PAKZ Proposal

November 29, 2005

This document describes proposed changes to P1363.2 D22 APKAS-PAKZ draft version D22 that addresses an attack on PAKZ. This proposal corresponds to the [GMR05] proposal discussed in the August 2005 meeting.

Figure 9.7.2—APKAS-PAKZ key agreement operation

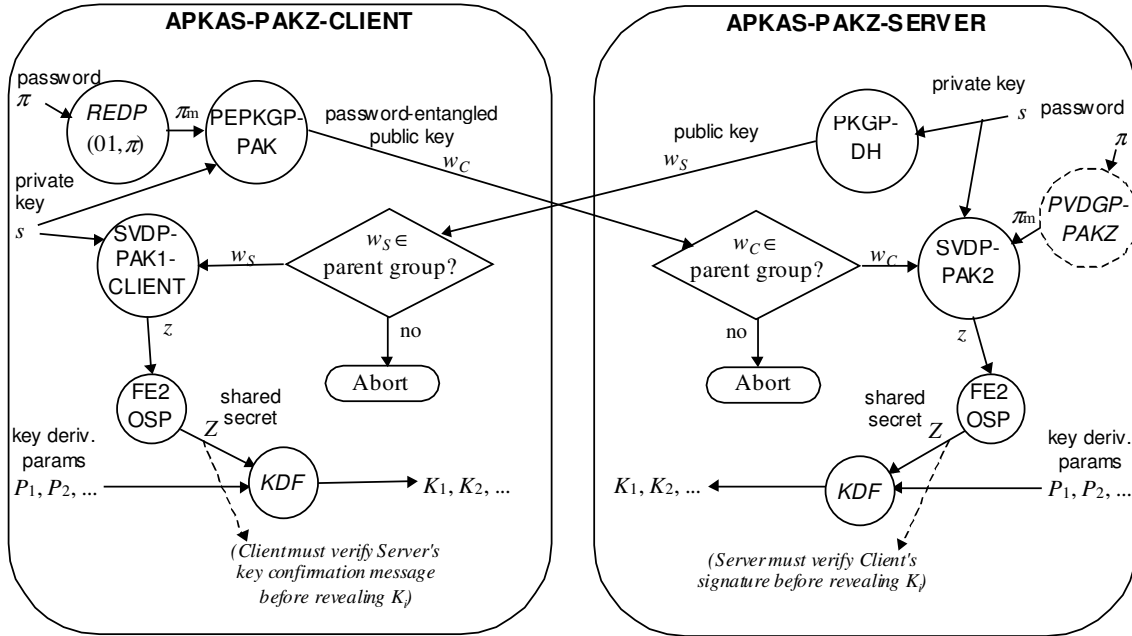
Editor's Note—The D22 PAKZ summary has not yet been updated with the July 2005 proposal.

<i>Client</i>		<i>Server</i>
Enrollment:			
PVDGP-PAKZ	$\pi_m = Redp(hex(01) \parallel \pi)$ $o_2 = Mgf(hex(02) \parallel \pi, uLen)$ Generate (u, v) sig keys $H_u = Hash_{SK}(o_u)$ $o_{ID} = ClientID \parallel ServerID$ $o_{u\pi} = o_2 \oplus u$	$\pi_m, v, o_{u\pi}, H_u, o_{ID}$ \rightarrow	$\pi_m, v, o_{u\pi}, H_u, o_{ID}$
Key Agreement:			
PVDGP-PAKZ	$\pi_m = Redp(hex(01) \parallel \pi)$		$s \in_R [1, r-1]$
PEPKGP-PAK	$w_C = (g \wedge s) * \pi_m$	$w_C \rightarrow$	Abort if $w_C \notin$ parent group
PKGP-DH	Abort if $w_S \notin$ parent group	$\leftarrow w_S$	$w_S = (g \wedge s)$
SVDP-PAK1-CLIENT	$z = w_S \wedge s$		
SVDP-PAK2			$z = (w_C * \pi_m^{-1}) \wedge s$

NOTE—The key agreement operation of APKAS-PAKZ has unilateral commitment from Client. Client must first verify key confirmation from Server, before using z.

Figure 9.7.3—APKAS-PAKZ key confirmation operation

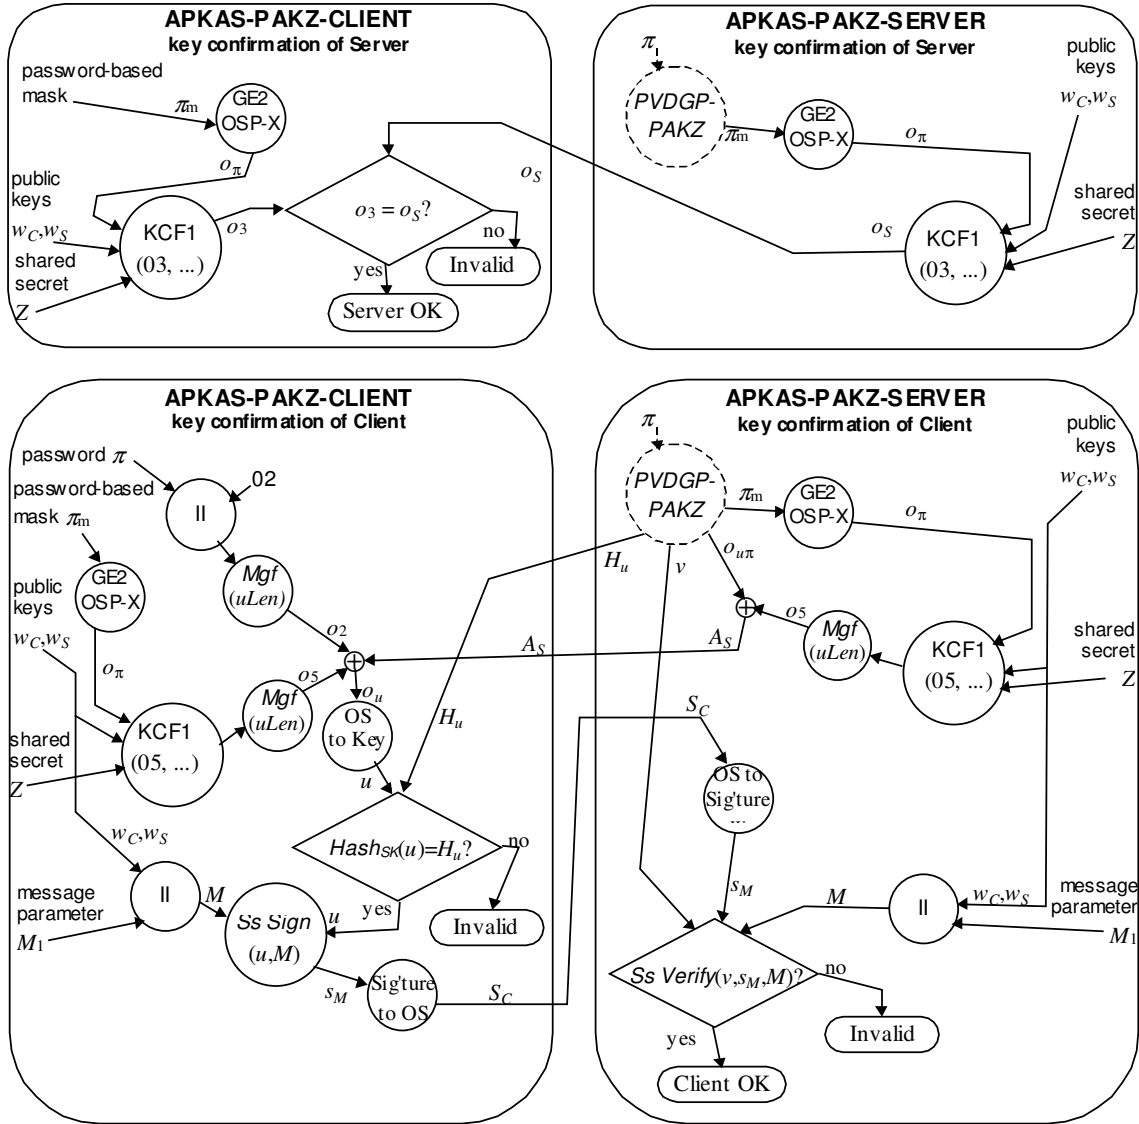
Key confirmation of Server:	$o_3 = \text{KCF1}(03, w_C, w_S, z, \pi_n^{(-1)})$ $o_7 = \text{KCF1}(05, w_C, w_S, z, \pi_n^{(-1)})$ $o_8 = \text{KCF1}(06, w_C, w_S, z, \pi_m)$ $o_5 = \text{Mgf}(o_7, uLen)$ $o_6 = \text{Mgf}(o_8, sLen)$ Abort if $o_3 \neq o_5$	$o_S = \text{KCF1}(03, w_C, w_S, z, \pi_n^{(-1)})$ $o_7 = \text{KCF1}(05, w_C, w_S, z, \pi_n^{(-1)})$ $o_8 = \text{KCF1}(06, w_C, w_S, z, \pi_m)$ $o_5 = \text{Mgf}(o_7, uLen)$ $o_6 = \text{Mgf}(o_8, sLen)$		
Key confirmation of Client:	$o_u = A_S \oplus o_5 \oplus \text{Mgf}(\text{hex}(02) \parallel \pi, uLen)$ Abort if $\text{Hash}_{SK}(o_u) \neq H_u$ Convert octet string o_u into u (opt) Abort if u is invalid $M = o_{ID} \parallel w_C \parallel w_S$ $S_C s = \text{Sign}(u, M \parallel s)$ Convert s into octet string S_1 $S_C = S_1 \oplus o_6$	$\leftarrow o_S$ $\leftarrow A_S H_u$ $A_S = o_{u\pi} \oplus o_5$ $S_C \rightarrow$	$S_1 = S_C \oplus o_6$ Convert octet string S_1 into s $M = o_{ID} \parallel w_C \parallel w_S$ Abort if $\text{Verify}(v, S_C s, M)$ fails
